APPENDIX 17

Road Safety Audit Report

Incorporating Stage 1 Completion of Detailed Design

Proposed Roundabout A259 at Climping

PROJECT			
Mulgrave Estates			
TITLE			
Land at Climping, West Sussex			
Proposed Roundabout			
DRAWN BY	DESIGN BY	CHK BY	DATE
JCB	GDB	GDB	23/03/16
SCALE	4724 / 002	B	1:825 @ A1 1:1250 @ A3

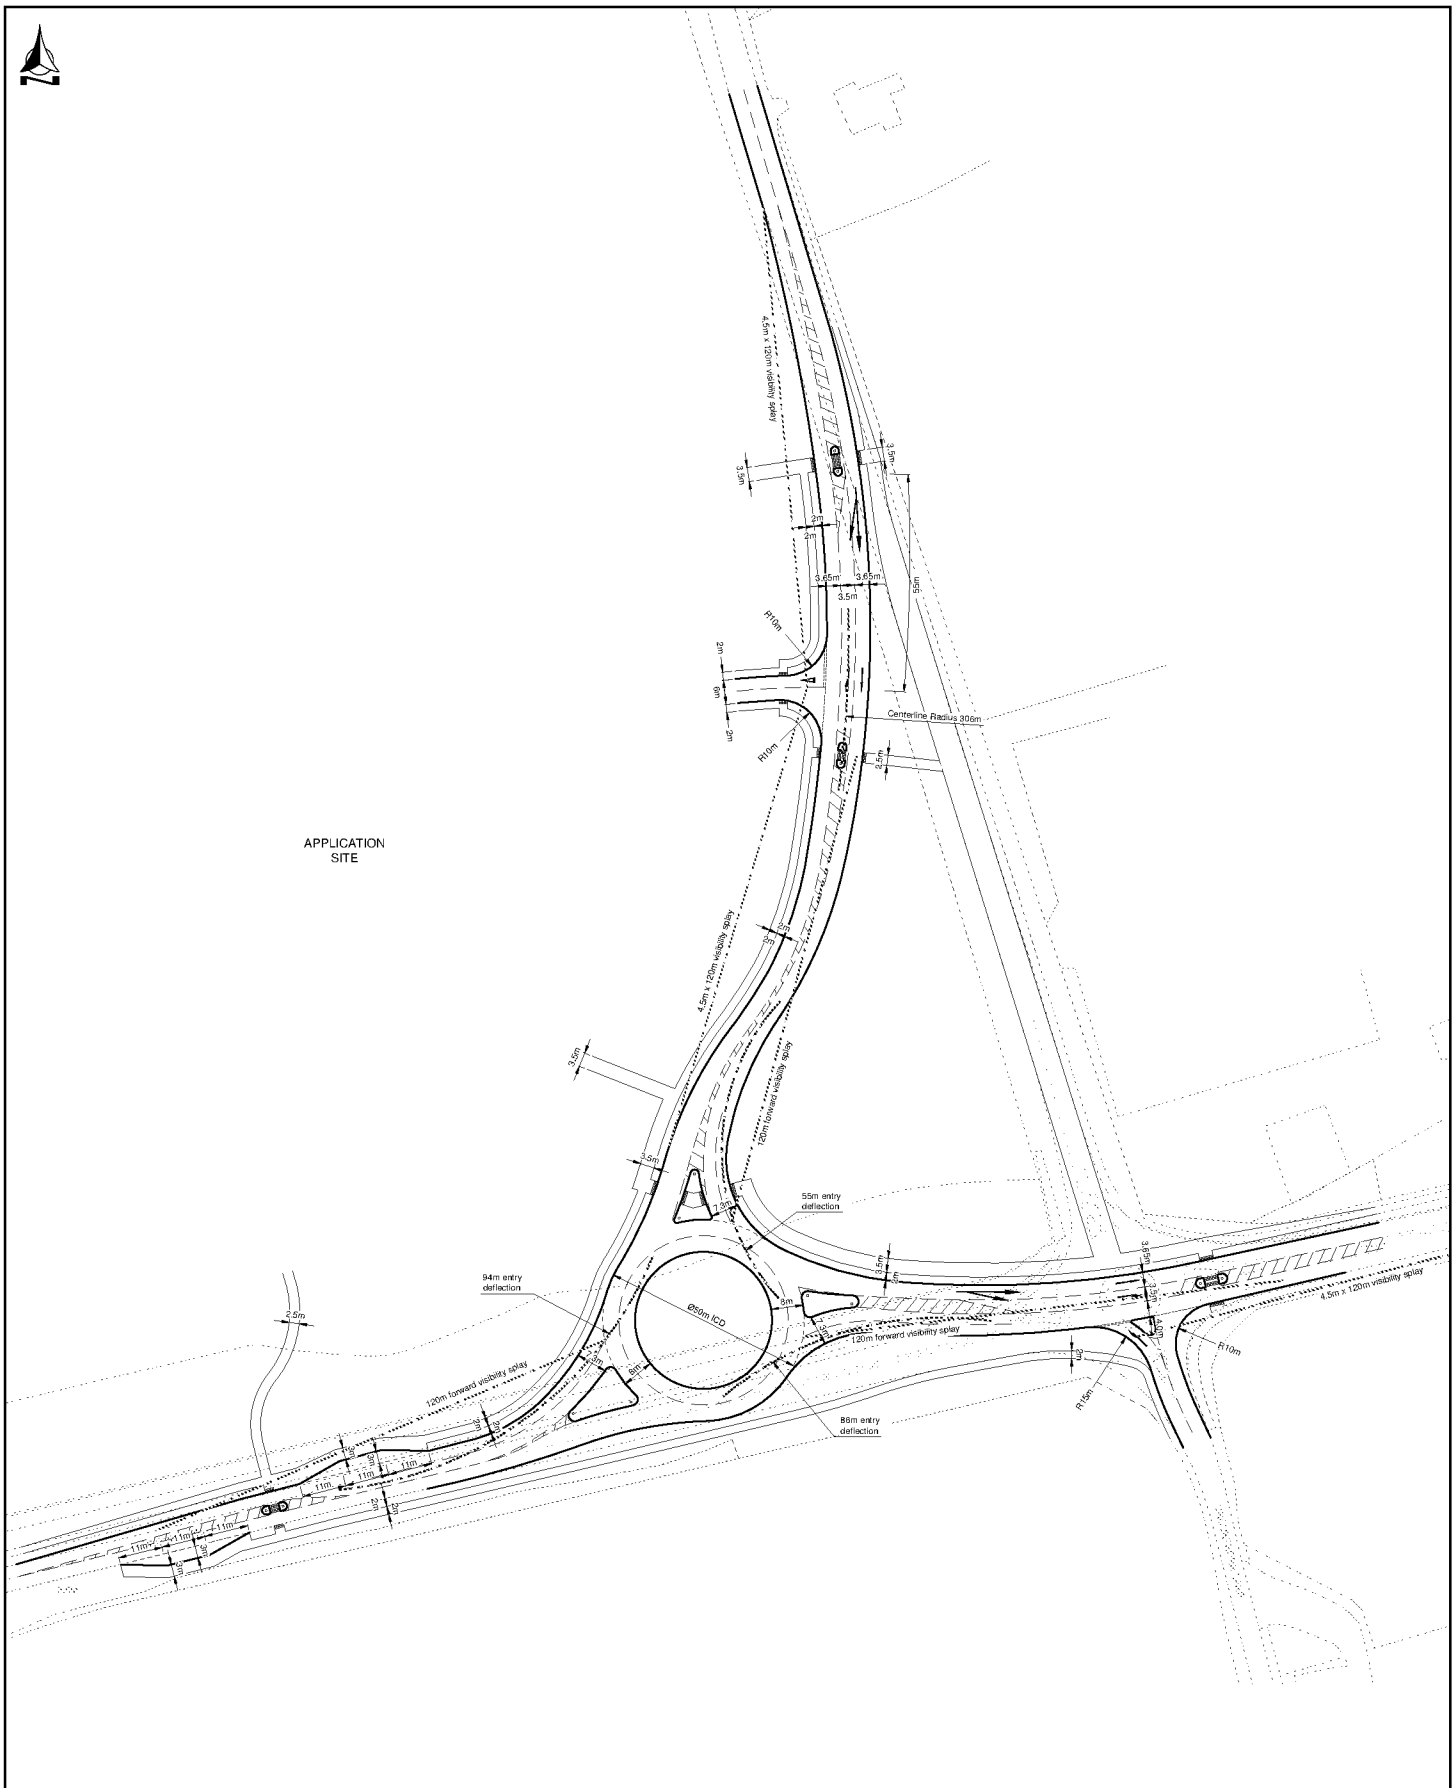
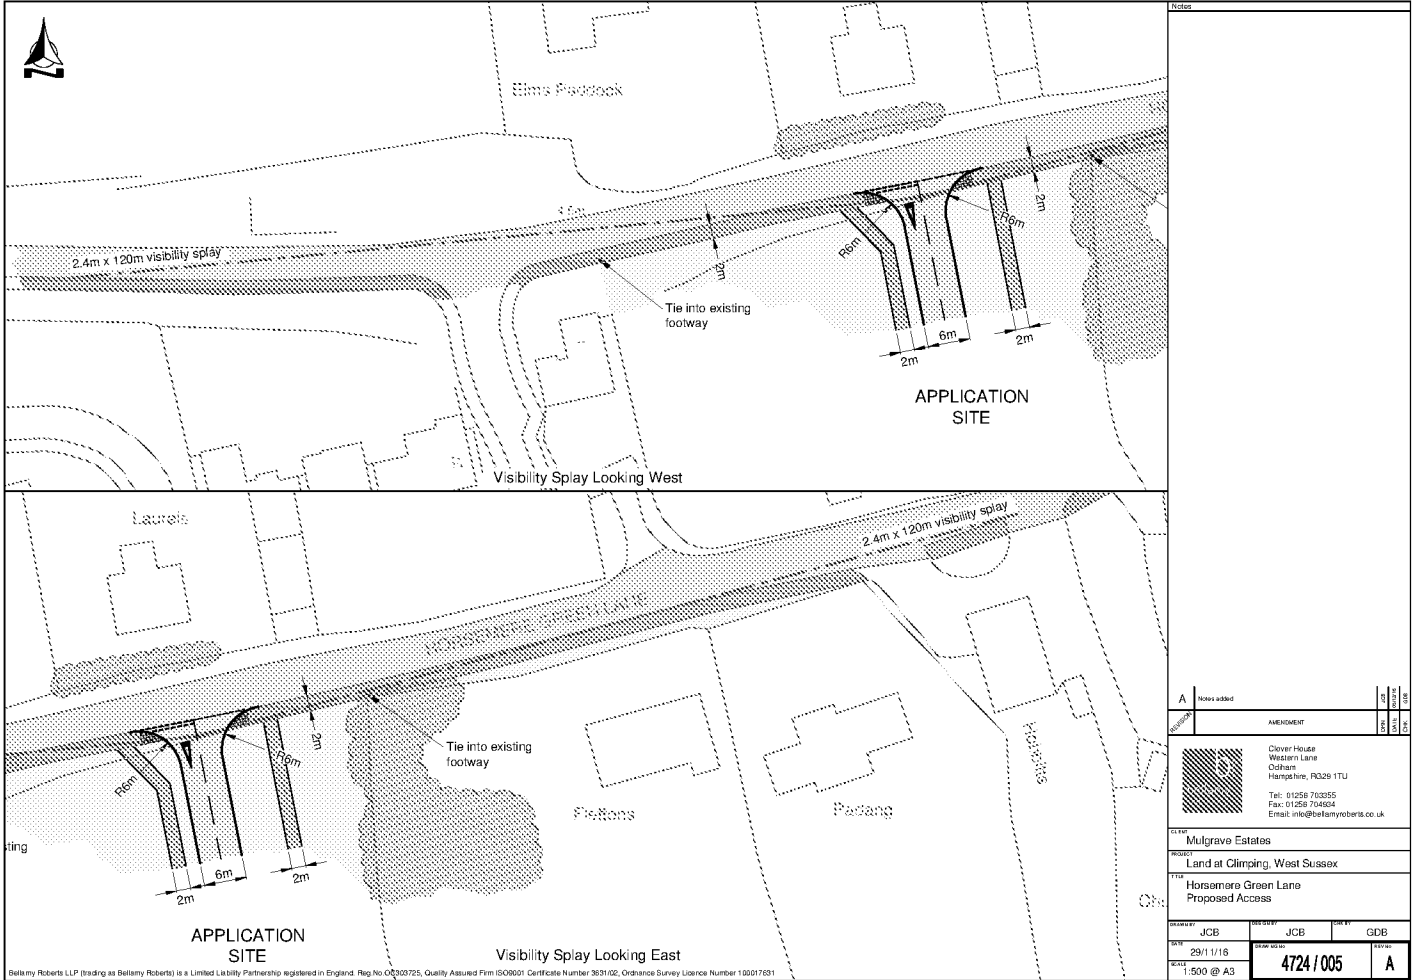
Audit Item No.	Audit Team Observation	Audit Team Recommendation	Design Team / Scheme Response
A.4	NON-MOTORISED USER PROVISION		
A.4.1	PROBLEM <i>South Coast Cycle Route 2 link removed</i> Accident Type <i>Vehicle cyclist collisions</i> Location <i>Crookthorn Lane to Old Church Lane cycle route</i> It is understood that the route of the South Coast Cycle Lane 2 is to be retained along the alignment of the existing Church Lane, thus allowing the section to become traffic free. However, the provision of a right turn lane to Crookthorn Avenue and relocation of the roundabout will restrict cycle movement across the A259. 	It is recommended that the footway to the east of Crookthorn Lane is improved to accommodate cyclists along with the proposed refuge island and cyclists are guided to utilise the shared footway cycleway and crossing to access the northern off-road section.	The section of footway to the east of Crookthorn Lane and the refuge island will be upgraded and signed accordingly.

Audit Item No.	Audit Team Observation	Audit Team Recommendation	Design Team / Scheme Response
A.4.2	PROBLEM <i>No cycle link provided</i> Accident Type <i>Vehicle cyclist collisions</i> Location <i>A259 and Crookthorn Lane west</i> The proposals include the provision of a 2 metre footway to the west of Crookthorn Lane along the A259 to a refuge and a link to the proposed development. This route links the local primary school with the site and is likely to be utilised by school children with parents, some of whom are likely to ride or scoot with insufficient width.	It is recommended that the proposed footway is increased in width to allow for cyclists.	Land is available and therefore the footway could be increased in width pending further consultation with the Highway Authority, but it is not considered necessary as very few primary school pupils are likely to cycle to school, and there is a cycle route via the northern side of A259 shown in the design.
